**ADDENDUM NO. TWO**

**DATE: March 20, 2024**

**RE: Highland High School  
Athletic Field Facility  
1800 Bench Road  
Pocatello, Idaho**

SPECIFICATION DRAWING ©2005 ABT, Inc.  
**INLAY GRATE - REINFORCED  
PERFORATED GALVANIZED STEEL**

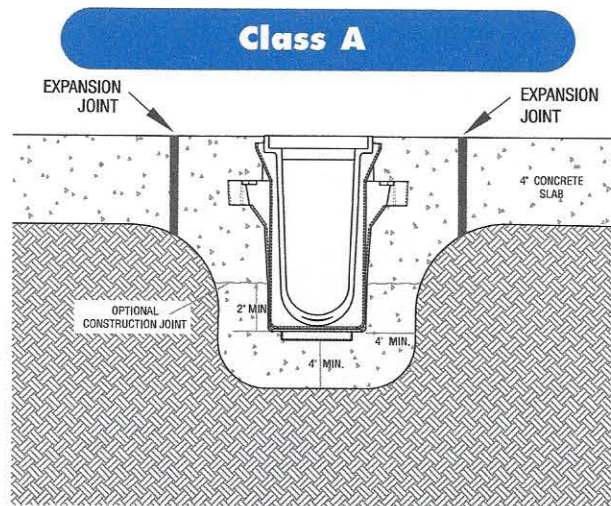
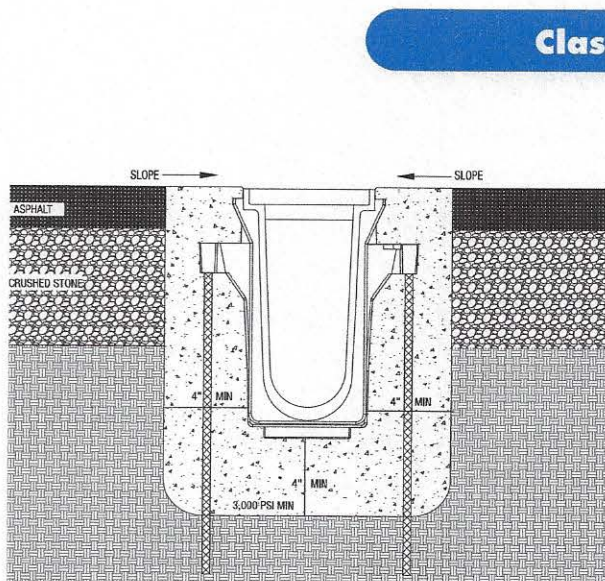
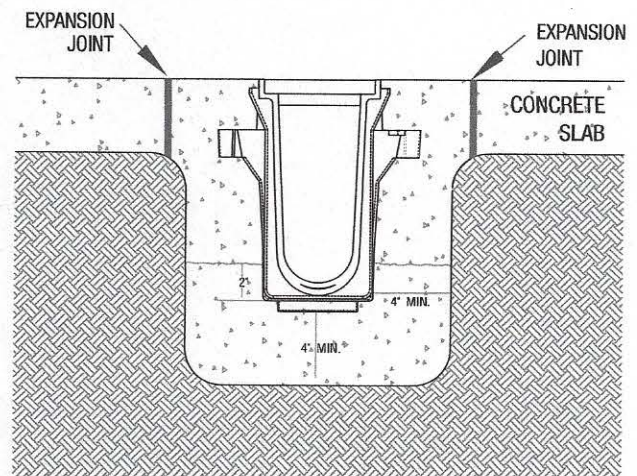
**Item VI-3.** Sheet SD2.2, Detail A. New metal grate and catch basin shall be replaced with 10 LF of trench drain such as ABT Drain Channel with #412 Galvanized steel grate (704-528-9806), or EZ-Track trench drain by NDS (800-726-1994). See 2 pages attached. Connect to existing catch basin with 6" pipe as shown.
